# 1970 Corvette: Service Bulletin: 1970 Corvette Folding Top Material Interference with Lid Pin Support

**Source:** Chevrolet Dealer Service Technical Bulletin

**Bulletin No:** 70-T-46

**Date:** Oct. 27, 1970

FIGURE 1

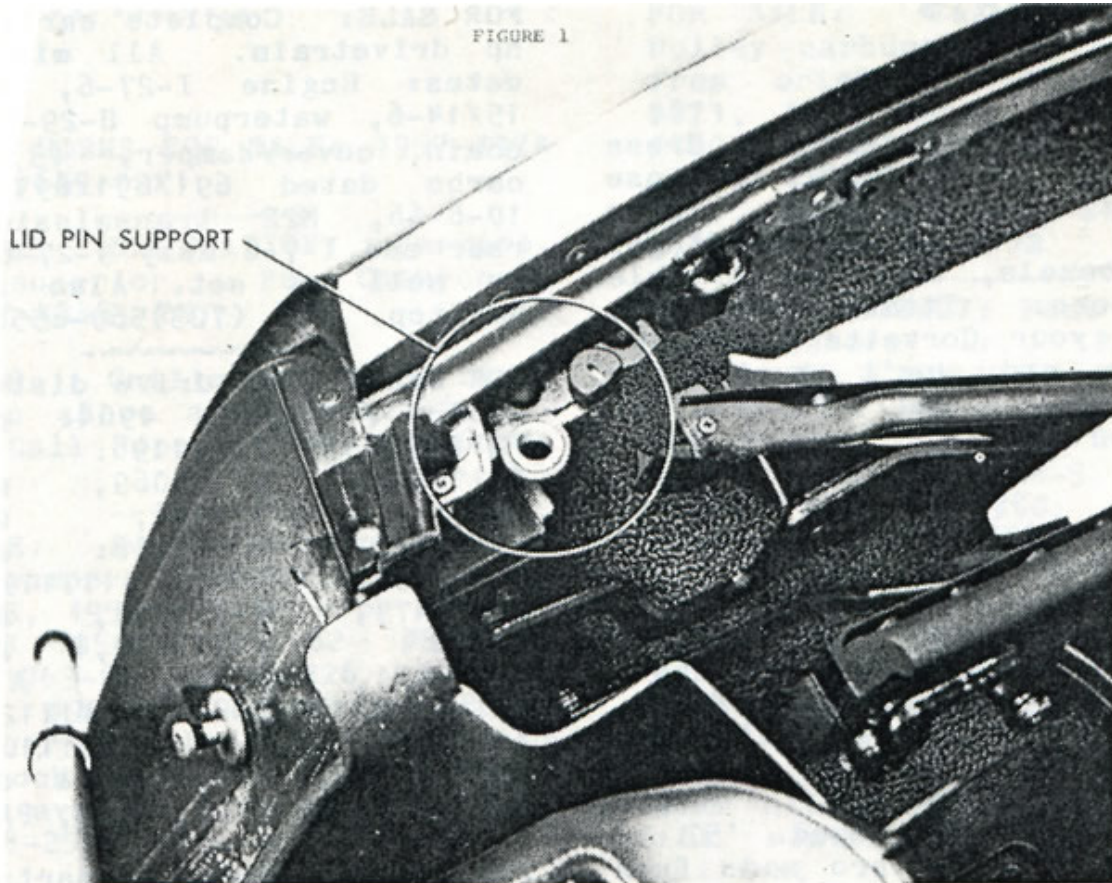
1970 Corvettes assembled prior to Serial Number S400748 may have interference between the folding top material and the top compartment lid pin support. This interference may result in damage to the folding top material.

1. Remove the lid pin support. (See Figure 1).
2. Grind 3/8" x 3/4" off the inboard edge of the support. (See Figure 2).
3. Reinstall the lid pin support and inspect to insure adequate clearance exists between the folding top material and the support.
